ECE/TRANS/WP.29/2007/74 17 July 2007

Proposal for Supplement 9 to Regulation No. 98

(Headlamps with gas-discharge light sources)

Submitted by the Working Party on Lighting and Light-signalling

# Figure 1

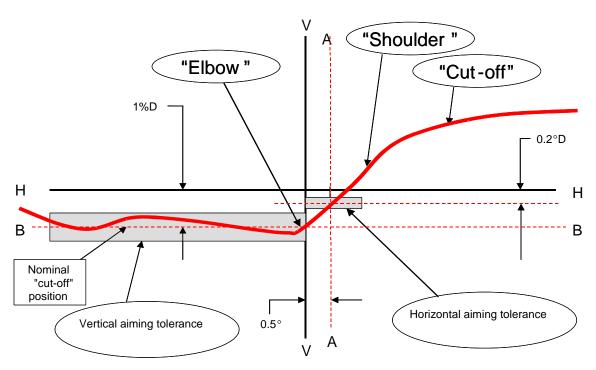
### Paragraphs 6.2.1. to 6.2.2.2., amend to read:

"6.2.1. The luminous intensity distribution of the passing beam headlamp shall incorporate a "cut-off" (see figure 1 below), which enables the headlamp to be adjusted correctly for the photometric measurements and for the aiming on the vehicle.

The "cut-off" shall provide:

- (a) For right hand traffic beams:
  - (i) a straight "horizontal part" towards the left;
  - (ii) a raised "elbow shoulder" part towards the right.
- (b) For left hand traffic beams:
  - (i) a straight "horizontal part" towards the right;
  - (ii) a raised "elbow shoulder" part towards the left.

In each case the "elbow – shoulder" part shall have a sharp edge.

- 6.2.2. The headlamp shall be visually aimed by means of the "cut-off" (see figure 1 below) as follows:
- 6.2.2.1. for vertical adjustment: the horizontal part of the "cut-off" is moved upward from below line B and adjusted to its nominal position one per cent (25 cm) below the H-H line;

- 6.2.2.2. for horizontal adjustment: the "elbow–shoulder" part of the "cut-off" shall be moved:
  - (a) for right hand traffic from right to left and shall be horizontally positioned after its movement so that:
  - (b) above the line 0.2° D its "shoulder" shall not exceed the line A to the left and
  - (c) on the line 0.2° D or below its "shoulder" should cross the line A and
  - (d) the kink of "elbow" should be primarily on the V-V line;

Figure 1: Measurement of "cut-off" quality

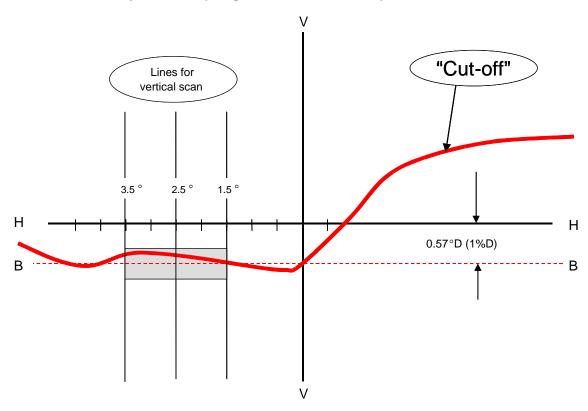
The part of the horizontal "cut-off" that serves for vertical adjustment shall be horizontal between 1.5° and 3.5° from the V-V line (see figure 1 below).

(a) The inflection points of the "cut-off" gradient at the vertical lines at 1.5°, 2.5° and 3.5° shall be determined by the equation:

$$(d^2 (\log E) / d\beta^2 = 0).$$

(b) The maximum vertical distance between the inflection points determined shall not exceed  $0.2^{\circ}$ .

Figure 2: Instrumental vertical and horizontal adjustment- horizontal line scan method

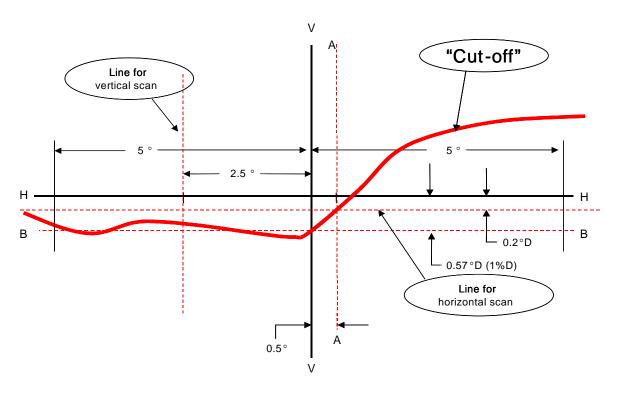
Moving upward from below the line B (see figure 2 below), a vertical scan is carried out through the horizontal part of the "cut-off" at  $2.5^{\circ}$  from V-V. The inflection point (where  $d^2 (\log E) / dv^2 = 0$ ) is determined and positioned on the line B situated one per cent below H-H.

(a) The "0.2 D line" method (see figure 2 below).

A single horizontal line at 0.2° D shall be scanned from 5° left to 5° right after the lamp has been aimed vertically. The maximum gradient "G" determined using the

formula  $G = (\log E_{\beta} - \log E_{(\beta + 0.1^{\circ})})$  where  $\beta$  is the horizontal position in degrees, shall not be less than 0.08.

The inflection point found on the 0.2 D line shall be positioned on the line A.

Figure 3: Instrumental vertical and horizontal adjustment-three line scan method

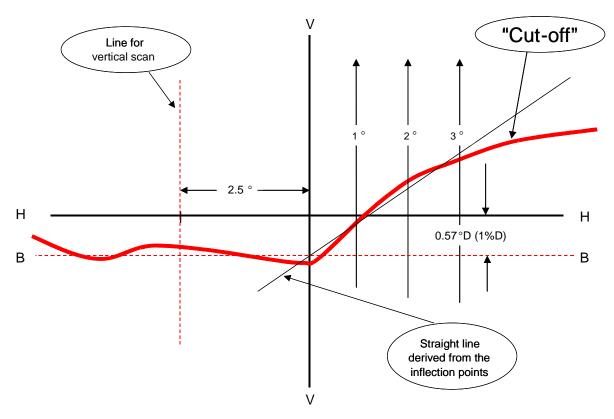
#### (b) The "3 line" method (see figure 3 below)

Three vertical lines shall be scanned from 2° D to 2° U at 1°R, 2°R, and 3°R after the lamp has been aimed vertically. The respective maximum gradients "G" determined using the formula:

where  $\beta$  is the vertical position in degrees, shall not be less than 0.08. The inflection points found on the three lines shall be used to derive a straight line. The intersection of this line and the line B found while performing vertical aim shall be placed on the V line.
